City of Houston Pedestrian and Bicycle Road Safety Audit

**Houston Safer Streets Initiative
Top 12 Intersections
Pedestrian/Bicycle Road Safety Audit
Second Six Locations**

Conducted:
January 28 – February 1, 2019

Figure 7: Seattle DOT example of two-way cycle track intersection crossing. (From: <https://streetsillustrated.seattle.gov/design-standards/bicycle/bike-intersection-design/>).

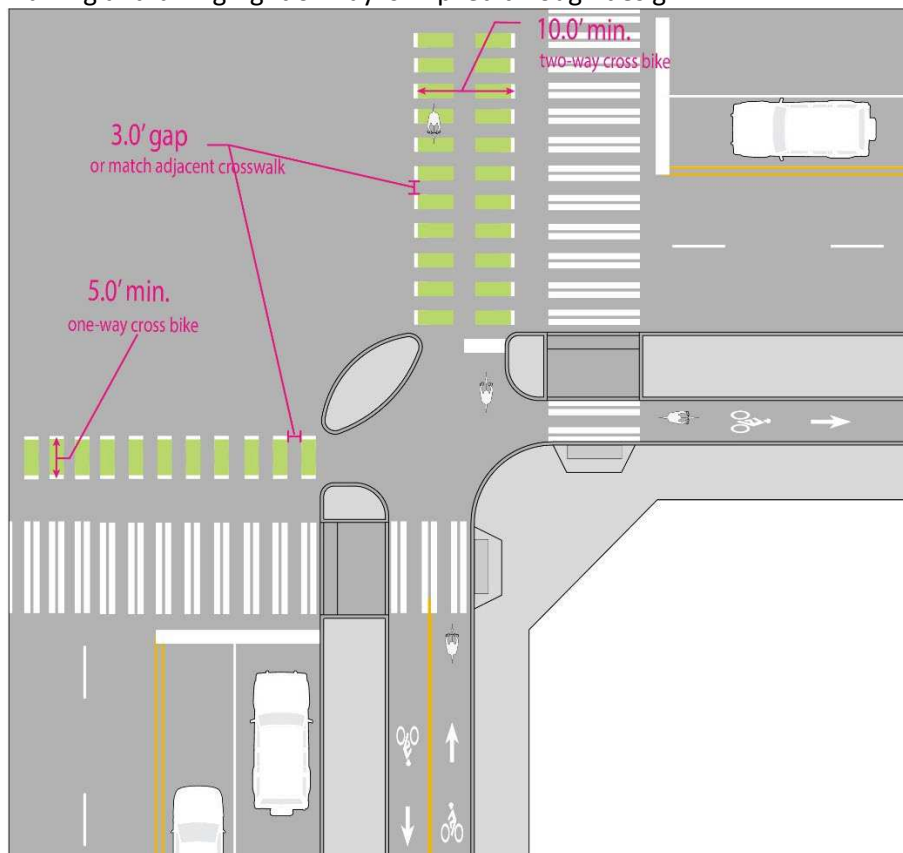
- Recommendation: Implement bicycle signal heads with separate phase from the pedestrian movement.
- Recommendation: Implement a cycle track crossing of Taylor consistent with newer design guides that separates bicycle traffic from pedestrian movements (See Figure 7).
- Recommendation: For future development and reconstruction of this area, consider design standards that leave the trail/sidewalk raised and patterned as a sidewalk across driveways so that walking and biking right of way is implied through design.

Figure 8: West of Memorial and Shepherd intersection with sidewalk that leads on to bridge area.

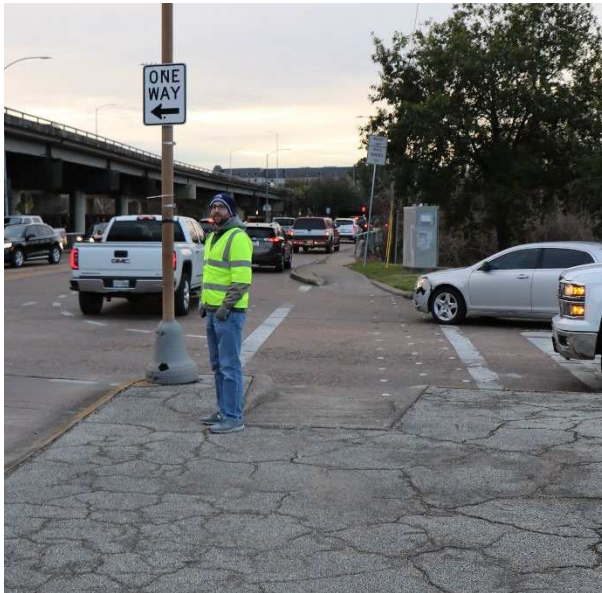
At the intersection of Memorial Parkway and Shepherd the existing configuration of the Shepherd overpass, Memorial underpass, and bus transfer and high school related walking and biking traffic presents several challenges. The west side sidewalk is relatively wide, but there is no pedestrian crossing across the south leg of Shepherd which currently has signal phasing that does not allow for a pedestrian movement. It also connects to a narrow sidewalk arrow along the west side of Shepherd over Buffalo Bayou, which should be closed and redirected to the new wider structure underneath the Shepherd overpass (See Figure 8).

- Recommendation: At Kirby/Allen Parkway/Shepherd implement basic pedestrian infrastructure upgrades to add accessible ramps, marked crosswalks, pedestrian signal indications, and associated improvements.
- Recommendation: At Shepherd and Memorial Parkway determine preferred configuration to provide for pedestrian movements in all corners including a plan for 5' minimum width sidewalks, ramps, railings, and pedestrian signal indications.
 - Option 1: Create left-turn only lane on northbound Shepherd and modify existing islands and signal head placement (See Figure 10).
 - Option 2: Add a new pedestrian/bicycle bridge just east of the existing bridge over Memorial Parkway.

Figure 9: East side of Memorial and Shepherd intersection with missing ramps, narrow walkway, and low railing.

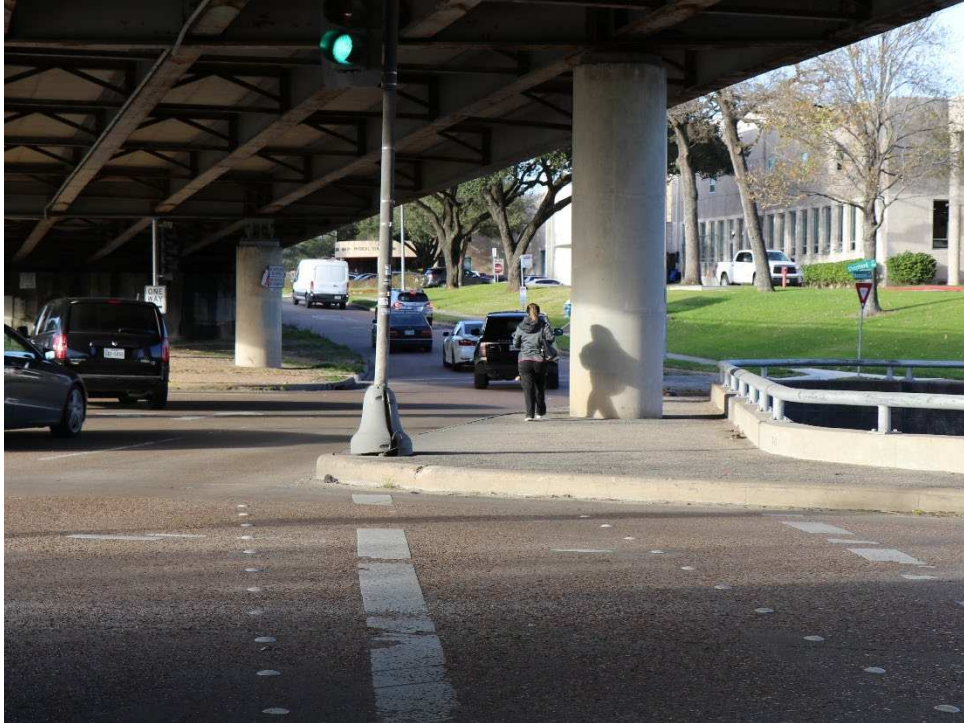
Along the east side, there are no pedestrian ramps, and an area that is less than 3.5' wide near the Shepherd overpass support, and a low barrier over the drop off to Memorial Parkway below. This low barrier area should be corrected with a pedestrian appropriate height railing and may need to be temporarily closed off in the interim.

In the longer term, full pedestrian movements with accessible ramps and pedestrian indicators and associated improvements must be made. This may require modifying the existing islands and signal head locations on the bridge over Memorial. One option may be to change the inside northbound lane to a left turn only lane and to move it to the west of the west Shepherd overpass pillar. With only one lane passing between the Shepherd overpass pillars, the island on the east side could then be widened to provide a full width pedestrian area and improved with new ramps. A second option would be to place a new pedestrian/bicycle use bridge over Memorial just to the east of the existing bridge. As changes are made, the signal phasing should be adjusted to allow for pedestrian crossings of all four legs of the intersection. The sidewalks leading to the west narrow sidewalk along Shepherd over Buffalo Bayou should also be permanently closed such that pedestrians are never directed to that area.

- Recommendation: Work with developer of southeast quadrant parcel to program pedestrian and bicycle accessible improvements to the intersection of Kirby/Allen Parkway/Shepherd.
- Recommendation: Close off the area over Memorial Parkway with the existing low railing.

Figure 11: Area between Smith and Bagby for possible curb extensions (Google Earth).

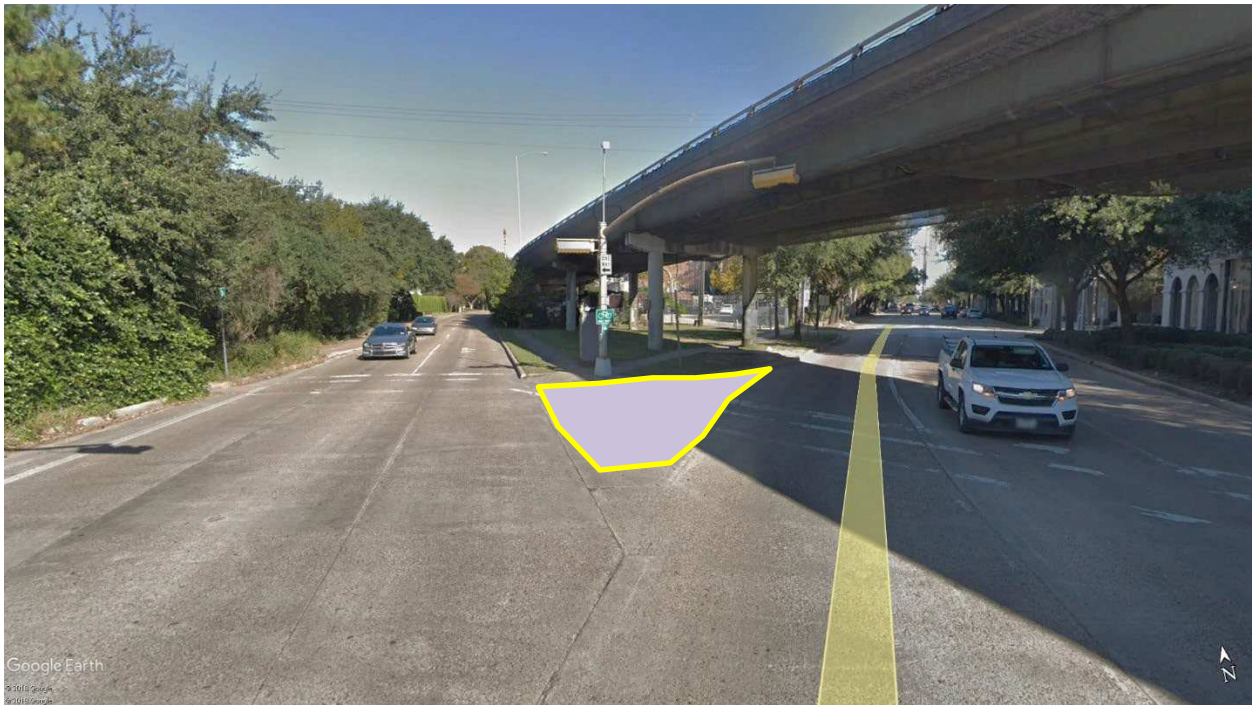
vehicle traffic in that lane merged into the adjacent through-lane at the intersection. The current configuration allows for higher speeds and late merges, both of which may affect the safety and comfort for other roadway users, and there is a potential to reconfigure how the lanes are dropped in the few blocks approaching the intersection to provide enhanced walking and biking comfort and to possibly extend the bicycle network north along Smith. Additionally, the right-side curb along Smith can be reconstructed to fit the currently allowed movements, which would provide a larger waiting area for bicycles attempting to cross Smith and Bagby, where the current waiting area is narrow and not adequate for more than one or two bicycles at a time.

- Recommendation: Widen the sidewalk/path between Holman and Hawthorne for pedestrian/bicycle use (10' minimum, 14' or more desired) (See Figure 12).
 - Recommendation: Adjust the curb between Bagby and Smith to place a wider refuge area using unused pavement (See Figure 11).

Figure 14: Cycle track approach to intersection.

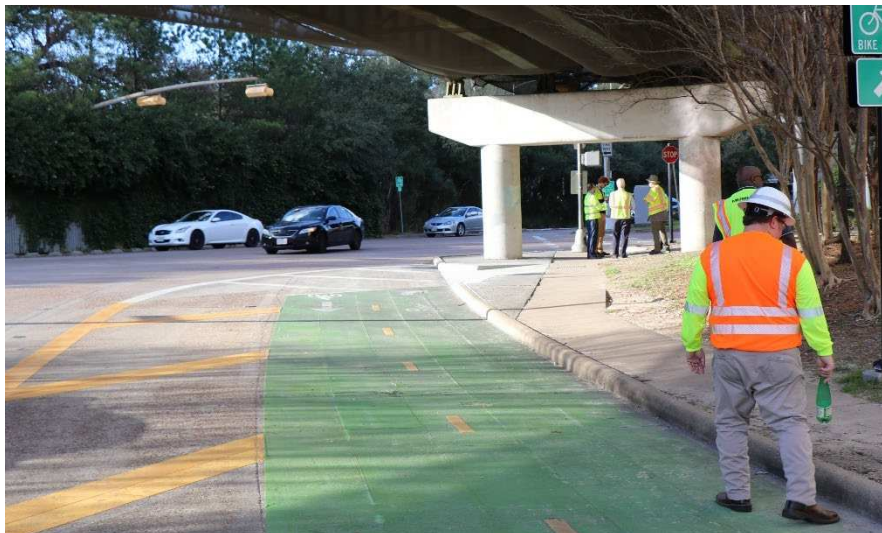
stretch of two-way cycle track proceeding east on Holman (See Figure 14). The crossings of Smith and Bagby are made in two stages with the walk indication. At the time of the review there was a conflicting stop sign facing approaching bicycles moving westbound into the intersection. The crossings of Smith and Bagby would benefit from modifications that maintained the cycle track appearance through the intersection (See Figure 7) and the connection to Hawthorne, including wider paths and dual use green and white crosswalk markings.

- Recommendation: Place combined crosswalk / cycle track markings that better links the end of the cycle track to the east and the path to Hawthorne on the west (See Figure 14 and Figure 7).
